DMURS ASSESSMENT REPORT

Proposed Residential and Commercial Development
at Carcur Park, Wexford

Prepared by
Roadplan Consulting

DMURS Evaluation Matrix

Arthur Murphy & Co. PL-01 Site Overview

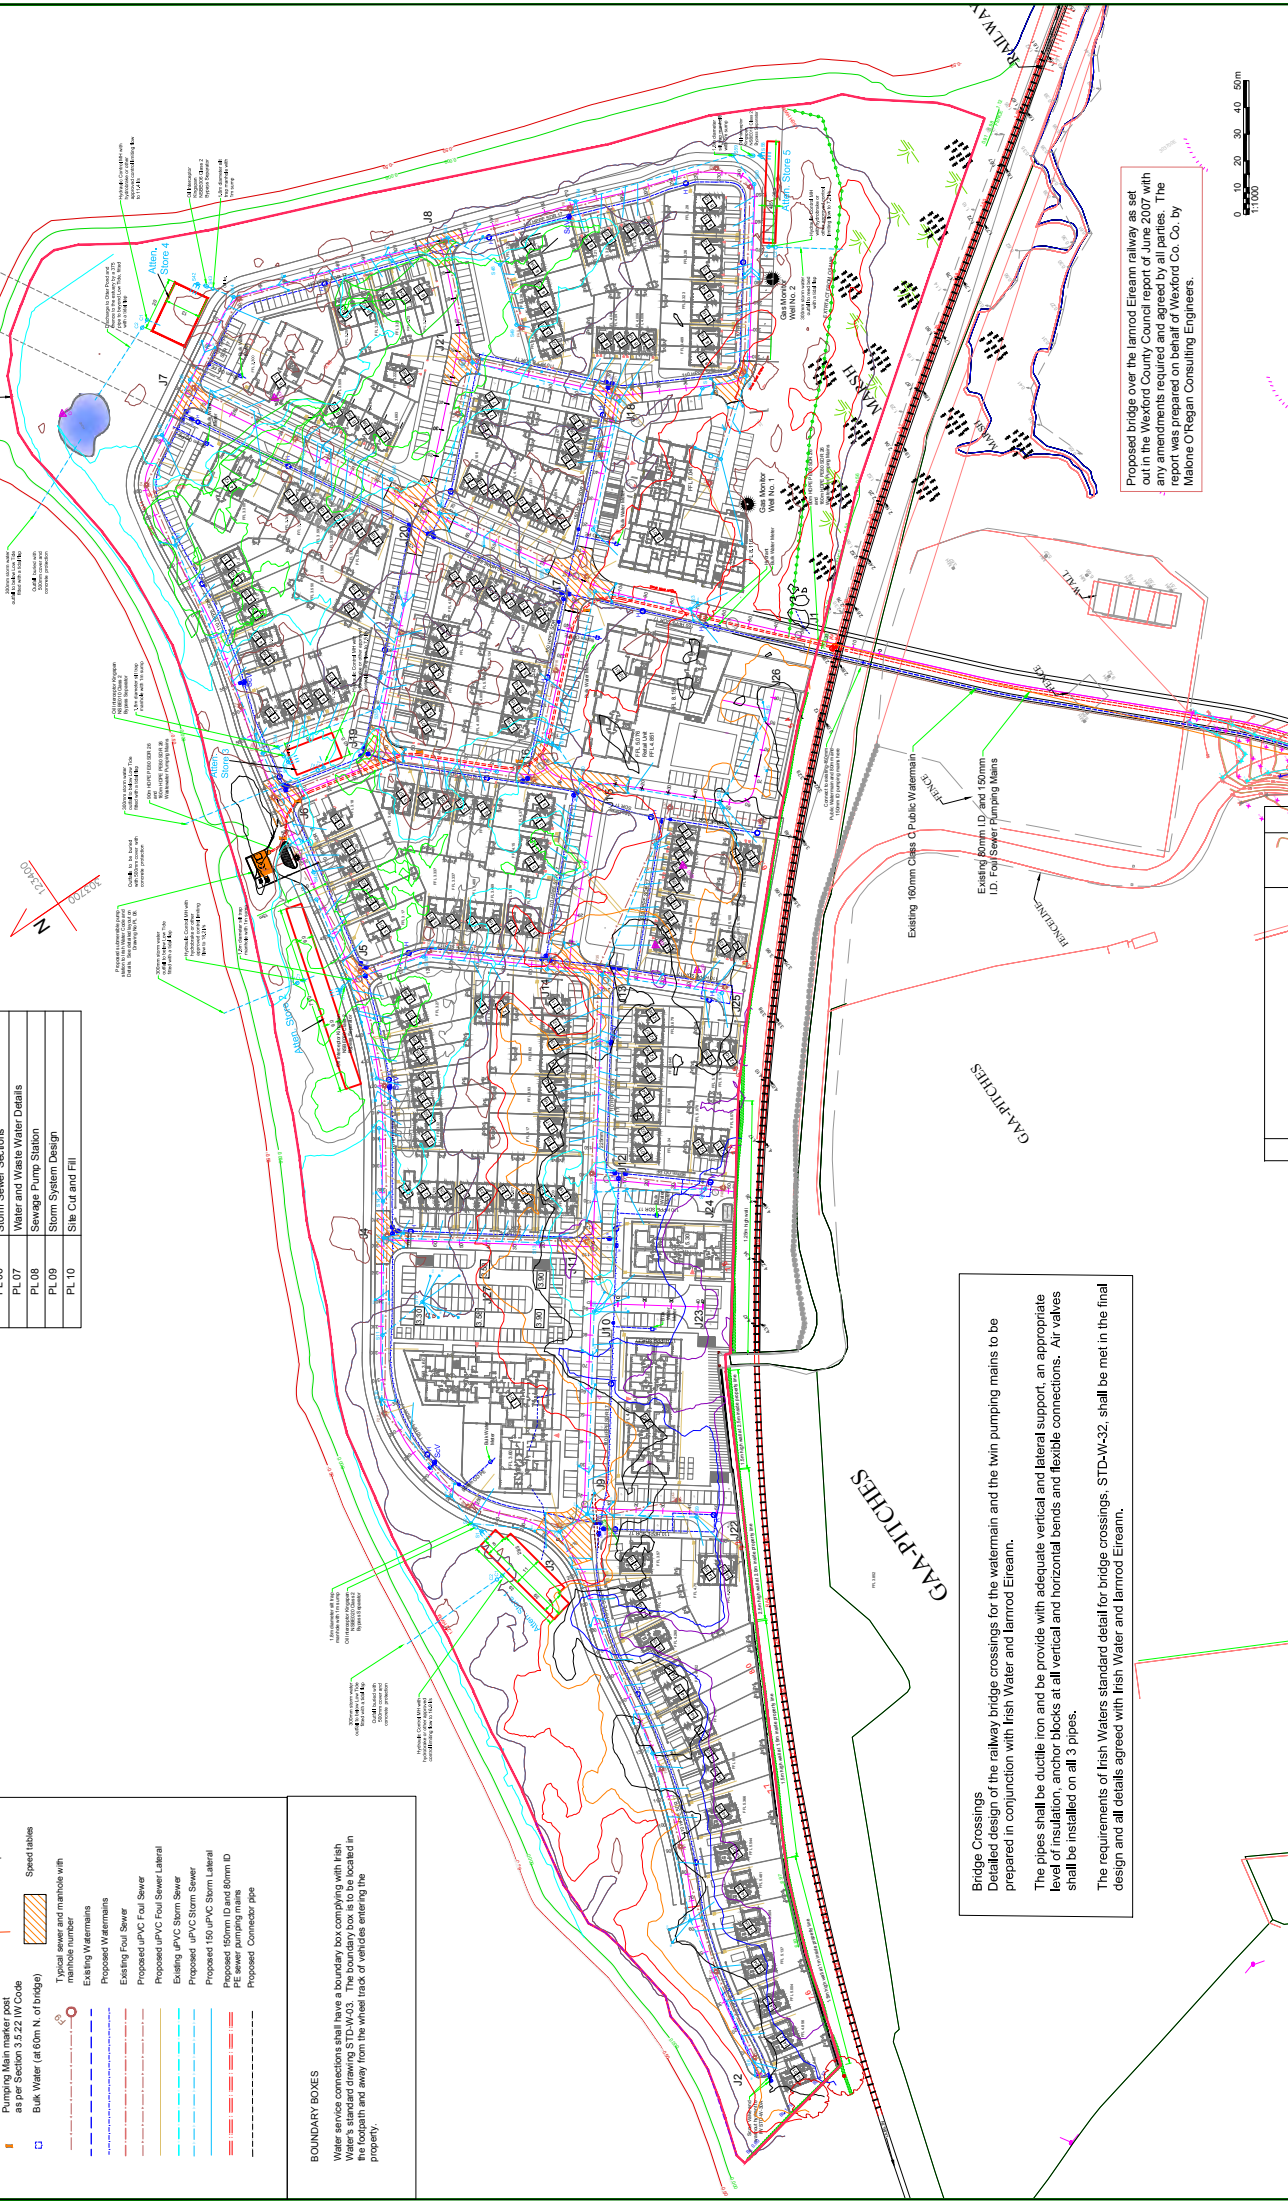
In relation to the streets that will form the Inner Orbital Rd there is an abrupt change in direction of the alignment at Junction 17. The quality of alignment is in marked contrast to the designed alignment of the existing section of inner orbital Rd that runs to the railway. The section through the development site should be designed, at construction stage, to comply with DMURS.

- Bend at J3 – which arms form the mainline?
- Bend on link J6 to J7
- Bend on link J7 to J8
- Bend on link J8 to J18

Stopping sight distance is not constrained on the inner orbital Rd. on the local roads stopping sight distance should be checked and provided at two bends on link J8-J18

There is roadside parking along the Inner Orbital Route. When in use the sightlines relating to the minor roads of the three crossroads junctions will be obstructed. The parking shall be omitted where it would obstruct visibility splays.

Roadside parking will also obstruct junction sightlines at many of the Local streets within the development. The speed and volume of traffic will be low, and this is not considered a significant issue. The drawings appear to indicate that table junctions are to be provided throughout. This would assist in the safe interaction of turning traffic. The DMRB permits "minor encroachments". Junctions should be checked to ensure that this is the case, and the layout amended if not.

These minor issues can be easily addressed at the detailed design stage to ensure all parking and junction visibility is constructed in a compliant manner.

Proposed	Client	Scale	Drawn By	Checked By	Project Name
10/04/18 AM	William Neville & Sons Ltd. Rockfield House Spawford Road, Wexford	1:1000H 1:100V (A1)	AM	AM	ROAD LONG SECTIONS
			PL 04	A	Planning

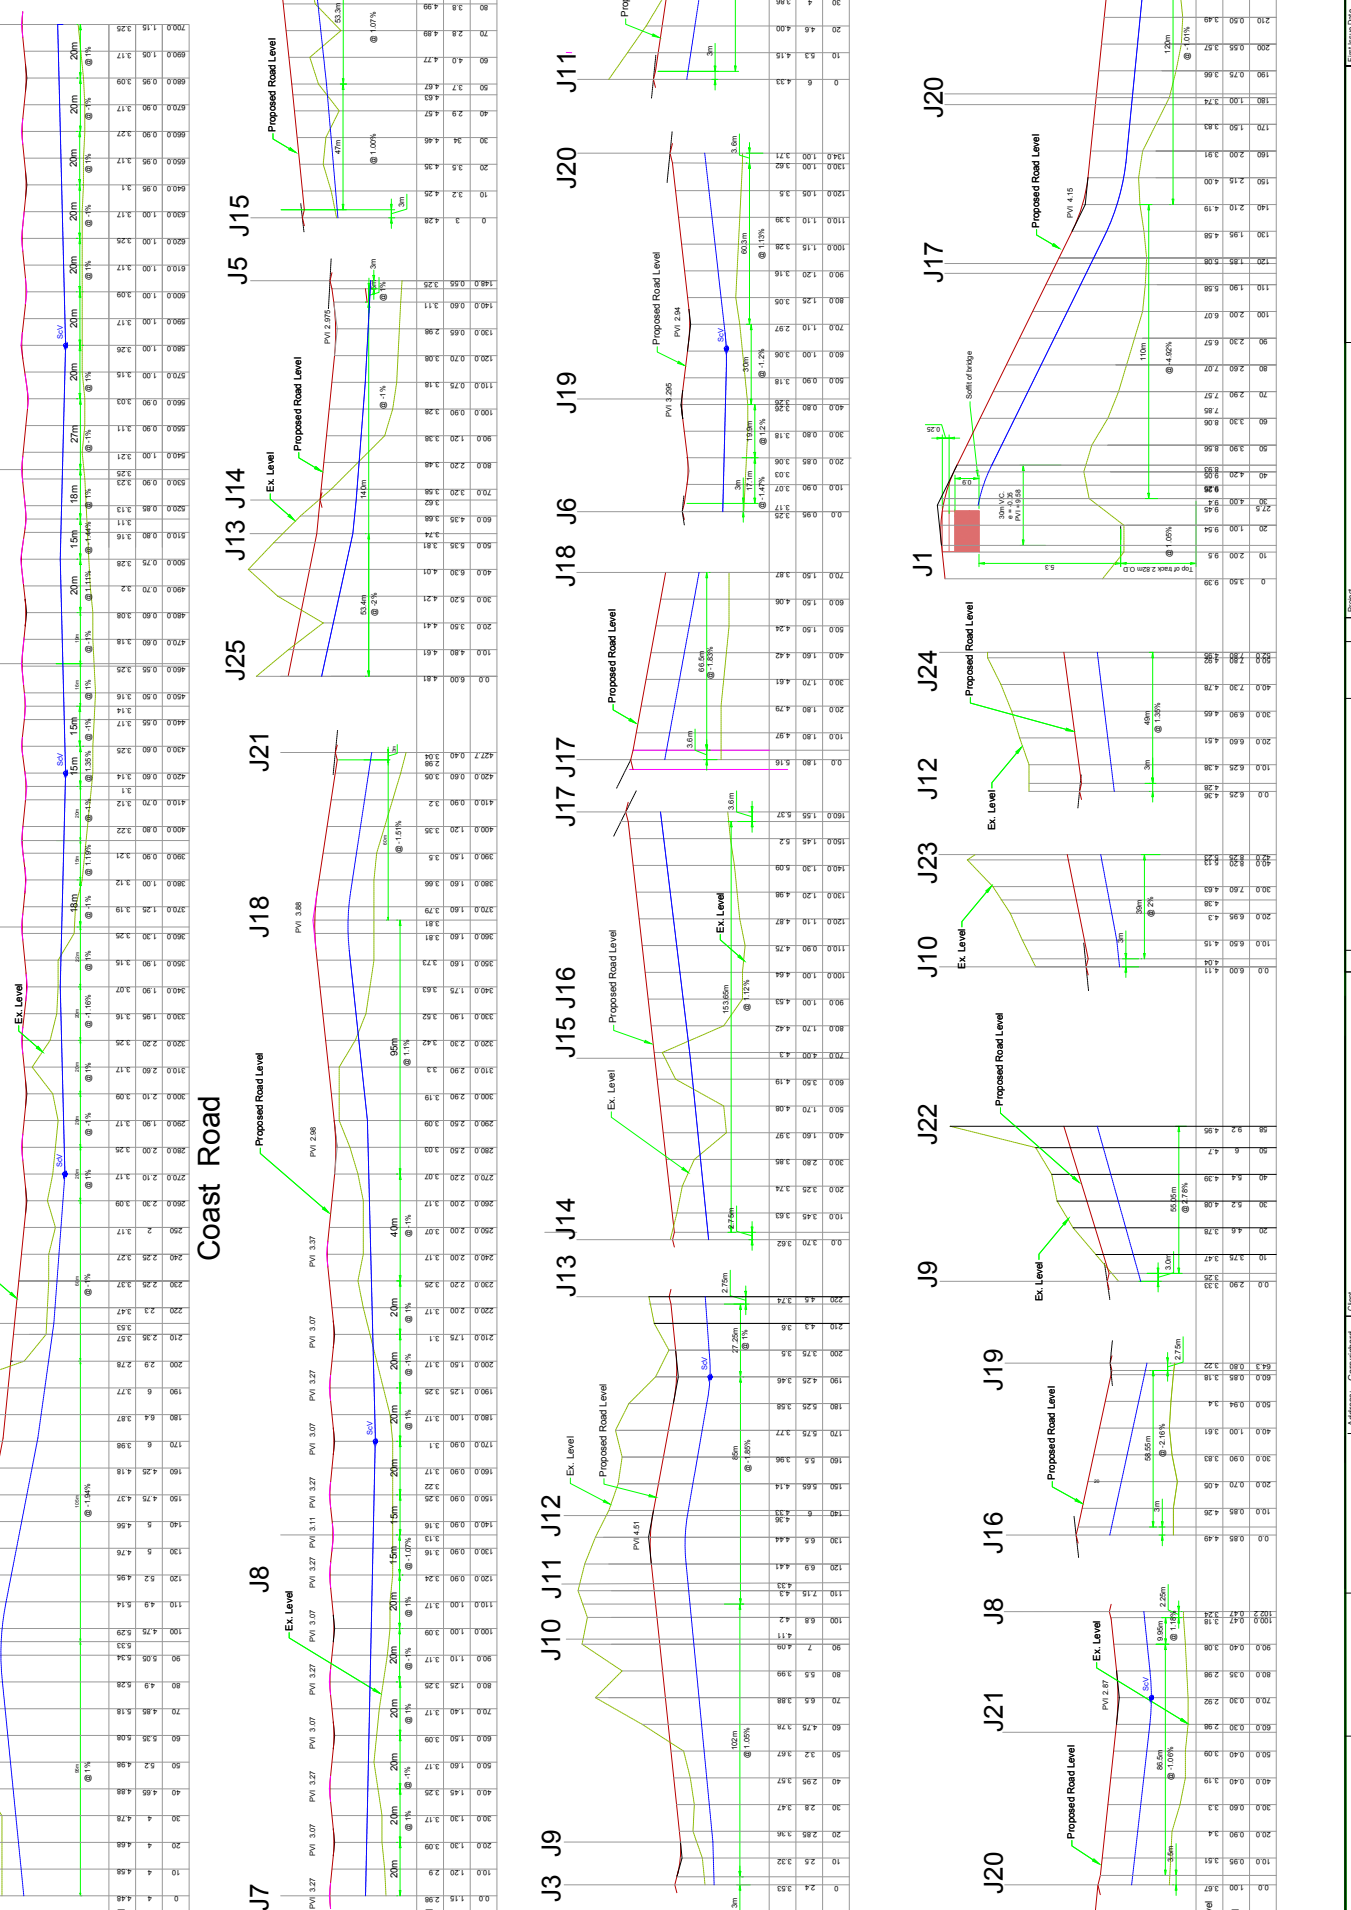
For the inner orbital route, the minimum crest K value is 8.2 and the minimum sag K value is 9.2. The crest value may be reduced to 6.5 by taking a two-step design standard relaxation as permitted by the Design Manual for Roads and Bridges. The vertical curves at these locations should be redesigned at construction stage.
